**MASTER DRAINAGE STUDY
UPDATE #3
(SUPPLEMENT to CLV CONDITIONS)**

Skye Canyon
City of Las Vegas, Nevada

**Subject: Master Drainage Study Update #3 for Skye Canyon (DS4420)
Supplement – Response to City of Las Vegas Conditions of Approval**

This letter is submitted in response to comments contained in the August 15, 2016 conditional approval letter received from City of Las Vegas (CLV) regarding the above referenced project. A copy of the CLV conditional approval letter is included in Appendix A for reference. The following comments have been individually addressed:

New Soils Survey Information

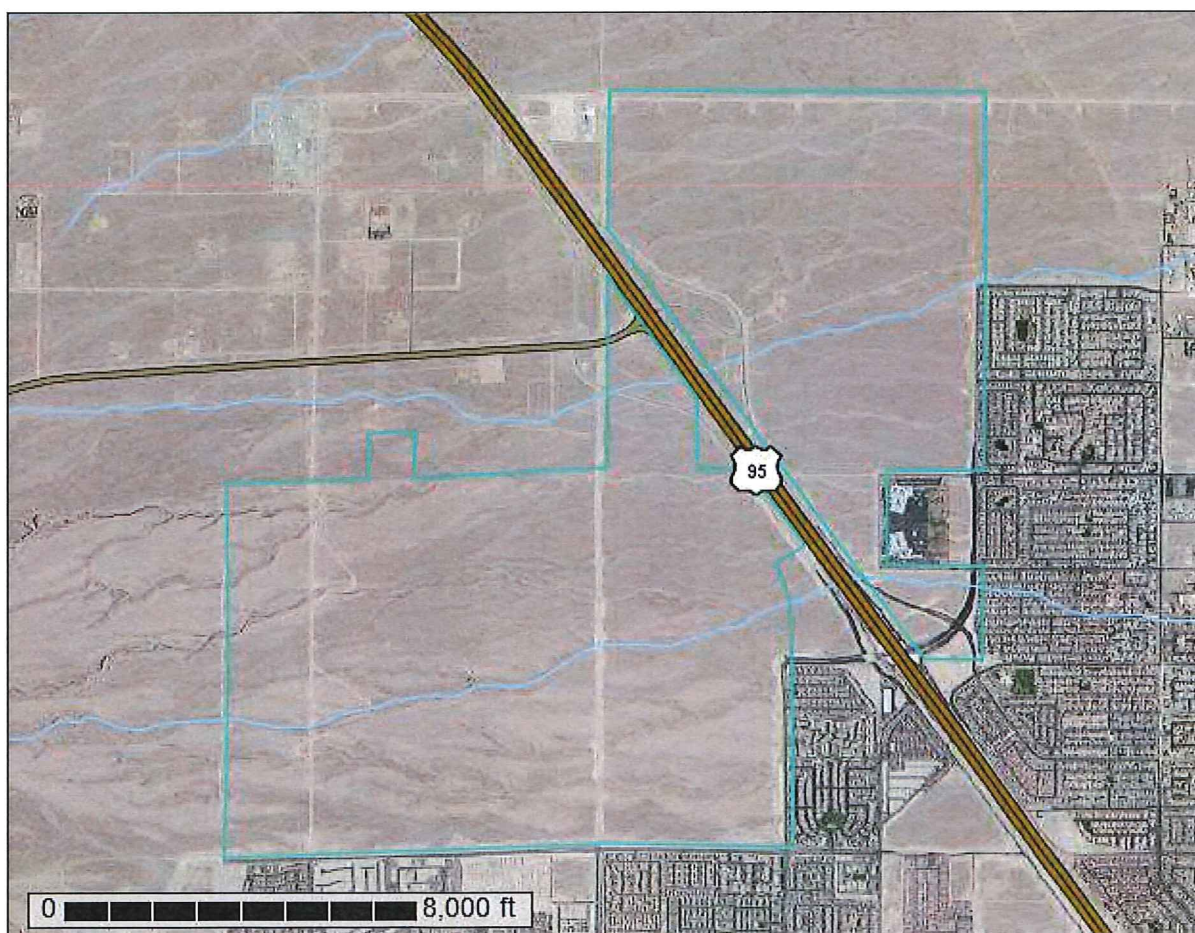
2. **Comment:** *The Regional Flood Control District has requested that engineering consultants utilize the latest NRCS soils data as a part of the drainage study parameters. The Master Plan Update shall discuss the soil data used in the analysis and discuss the impacts on the overall hydraulic analysis. Provide an updated HEC-1 analysis and address local and MPU facility size modifications, if necessary based upon the revised Soil Survey data. Update the NRCS soils data in the References (Section 7). Review and revise Exhibit & Figures accordingly. This needs to be addressed as supplemental information prior to the MPA approval.*

Response: A current soils report has been obtained from the NRCS Soil Data Mart (<http://websoilsurvey.sc.egov.usda.gov/App/HomePage.htm>) and these updated soil boundaries have been overlaid on the study's soils map, Exhibit A included in Appendix B, to demonstrate any changes in the soils utilized in hydrologic analysis. The methodologies for selecting curve numbers utilized in this study had observed the predominant soil group in each type and choose the appropriate curve number based on proposed land use from CCRFCD Manual tables. The below table represents a comparison of the soil groups presented in the approved study and the soil groups represented by the current NRCS soil survey in Appendix B.

Inspection of the revised Exhibit A reveals that Soils 155 and 400 have remained the same boundary and predominant soil group; therefore, it is anticipated little to no change occurs to the hydrologic analysis presented by this study. The previous Soil 191 that comprises the a small portion in the very far southwest corner of the site remains the same type but has changed to an improved hydrologic soil group "A" from the previous 'B' type. The previous Soil 540 that encompasses a majority of the east half of Skye Canyon, has been changed to Soil 314 which is considered a new soil type; however, its predominant soil group of 'A' allows for a better drainage class than the previous hydrologic group of 'B' for the same area. The Weiser portion of the composition has been re-defined to the lower 'A' hydrologic soil group. After further review of the soils composition between the two surveys, there are characteristics of the former 540 soil that are similar to the newly described 314 soil such as its alluvium formation and its sandy loam make-up that would allow for a well-drained drainage class. The new 314 soil composition shows that the restrictive layer is almost 6.5-ft deep before it can impede drainage and is described as "very rarely flooded". In conclusion, the change to 'A' soil per the new soil survey is considered acceptable; 'A' group, creates a hydrologic condition where storm runoff will not increase and in most cases improve or lessen the runoff produced by the subbasins in this study.

SHEET:
NEEA
36" RCP OUTFALL
PLAN AND PROFILE

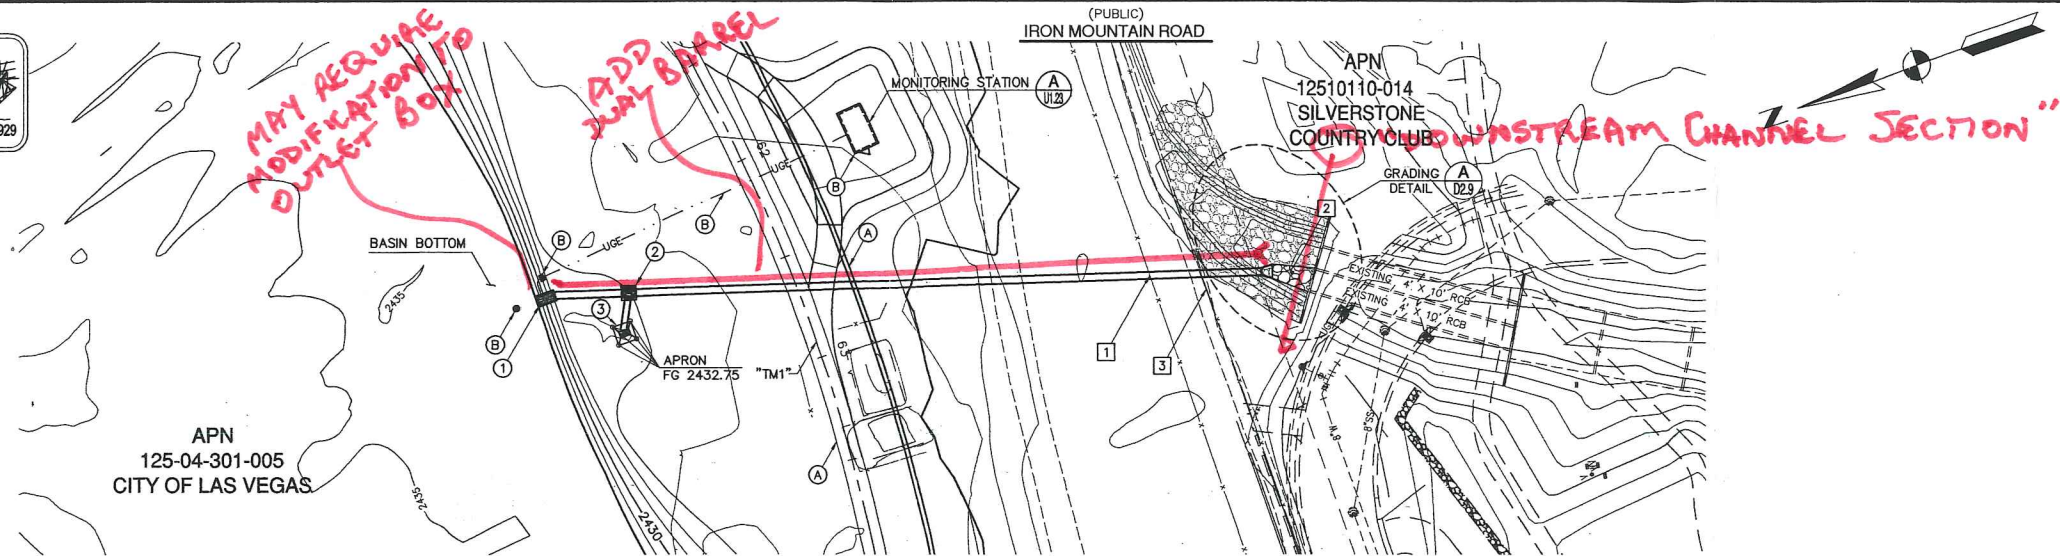
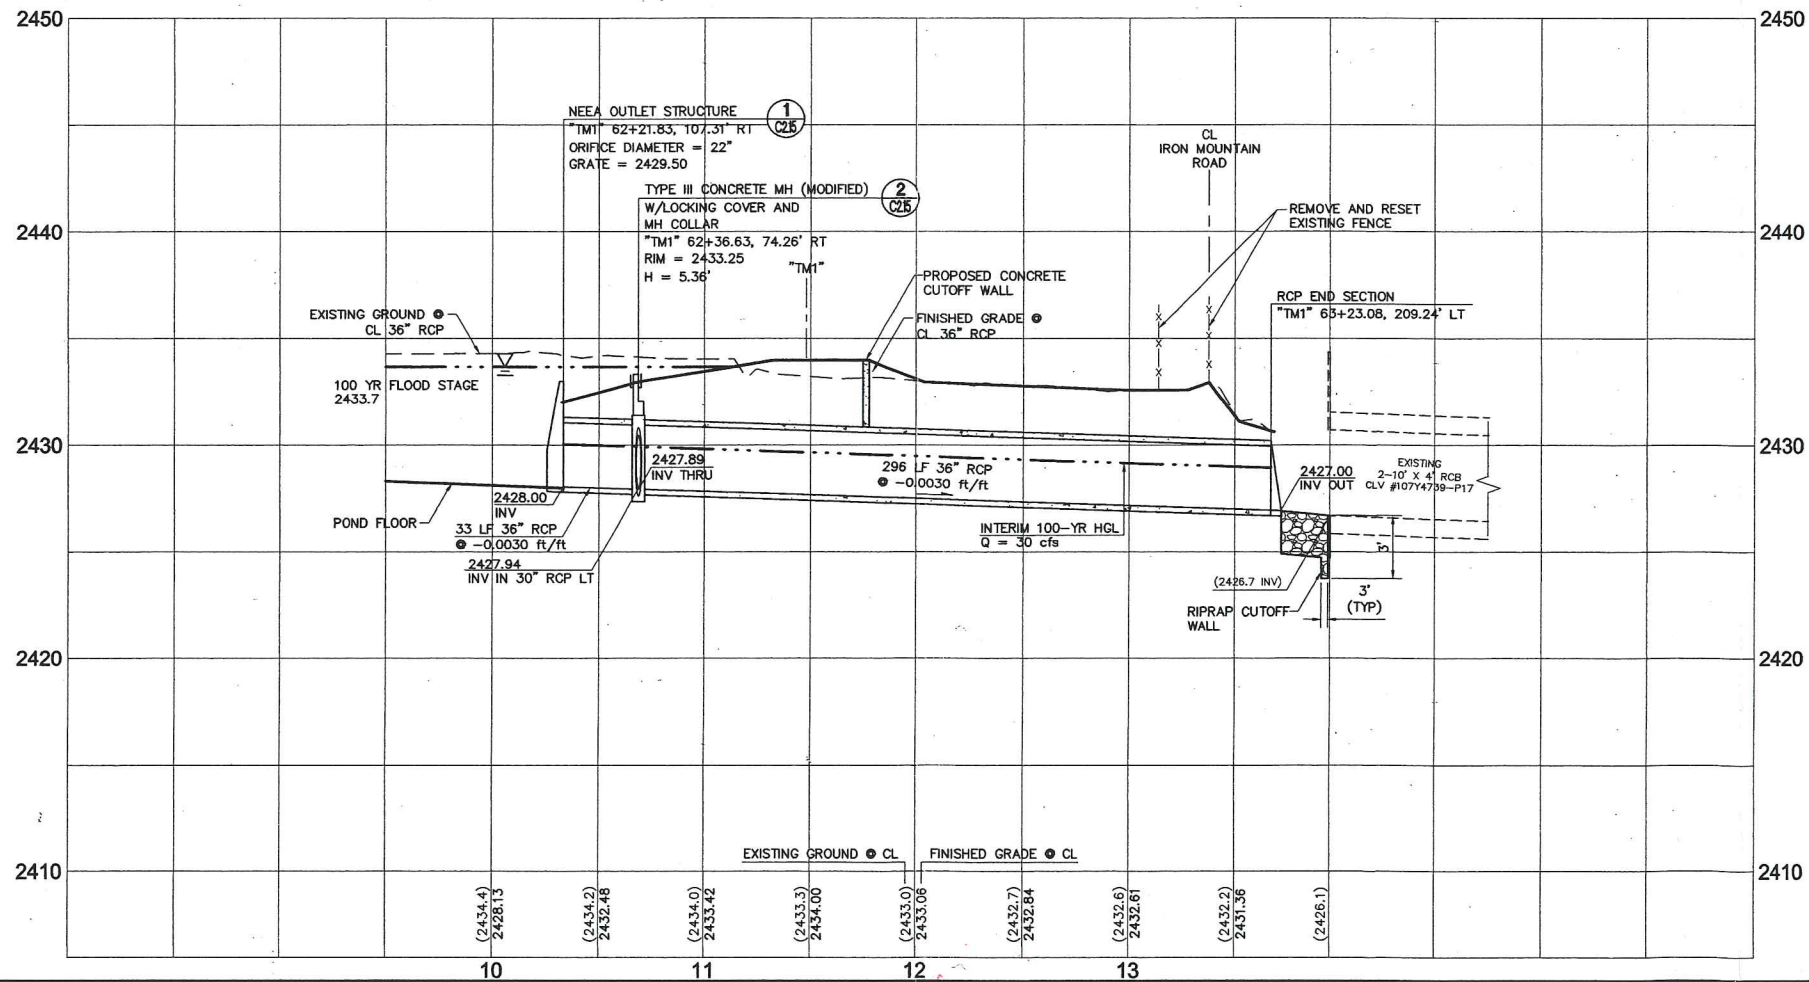
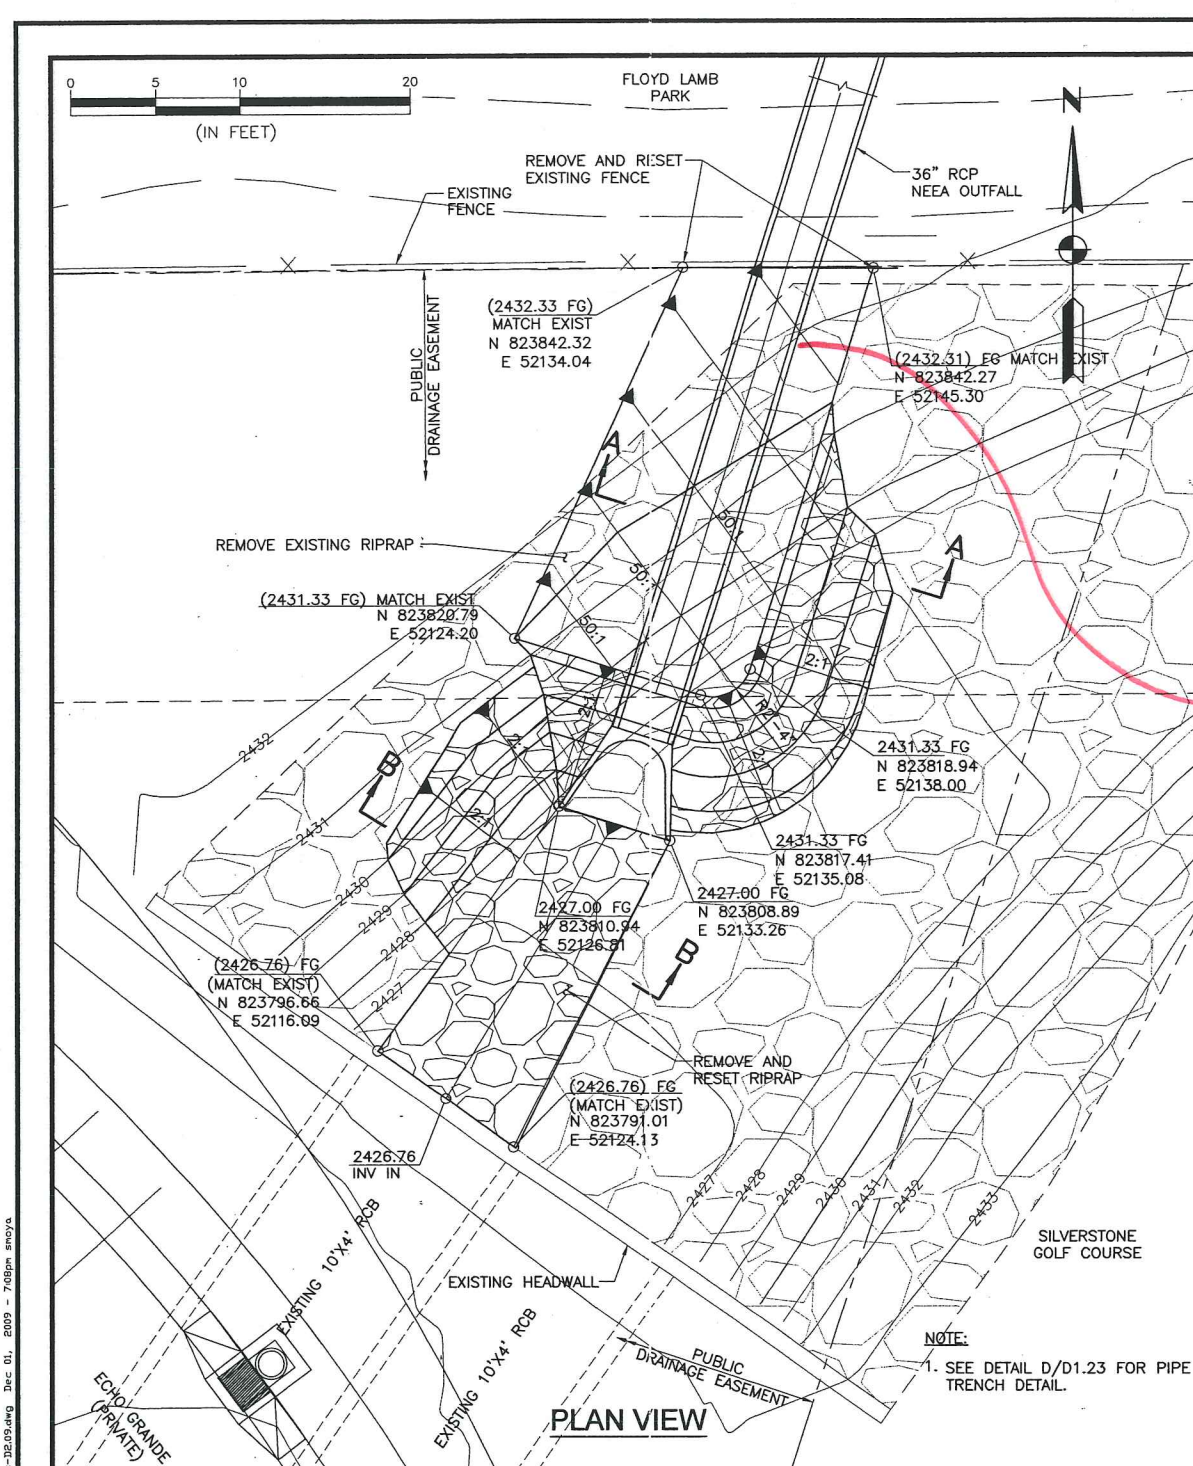
4. **Comment:** *This Update proposes to construct the Log Cabin Detention Basin #3 with flows that will increase the runoff volume routed towards the Tule Springs North Environmental Detention Basin (TSNEDB). The engineer proposes to modify the TSNEDB by removing the orifice plate at the detention basin outfall pipe to increase the outflow. Detention basin design uses the orifice plate to insure that the basin outfall remains under inlet control parameters per the HCDDM, Section 1200. Discuss the impact of removing the orifice plate and provide calculations verifying that the existing outfall will convey the proposed 78 cfs under inlet control conditions. Discuss the drain time impacts to the TSNEDB and the impacts to the downstream development. Alternatively, the TSNEDB may need modifications to meet the HCDDM requirements. This could include the expansion of the TSNEDB basin to increase the storage volume accordingly or replacement of the TSNEDB outfall. These or other modifications need to be conceptually addressed as supplemental information prior to the MPA approval.*

Response: A WSPG hydraulic model has been constructed based on design plan information for the outlet pipe to the North Environmental Detention Basin, and the outlet has been modified from a single barrel 36-inch RCP with 22-inch orifice that exists currently to a dual barrel 36-inch RCPs with 27-inch orifice plate on each barrel. This modification maintains the outlet and the detention basin to function under inlet control conditions (per CCRFCD Manual Figure 1001-b/c) for the new 100-year outflow of 80 cfs that formerly was designed as 30 cfs. The stage-discharge relationship table for the TSNEDB, identified in the HEC-1 as 'TULEDB', has been updated accordingly and the adjusted HEC-1 models have been included on a CD-ROM included in Appendix C. Note that only the following HEC-1 models that addressed the modification to the North Environmental Detention Basin have been included in this supplement:

**NEW 100-YR
WSE =
2433.7'**

**NOW (2) BARREL
NOW 27"**
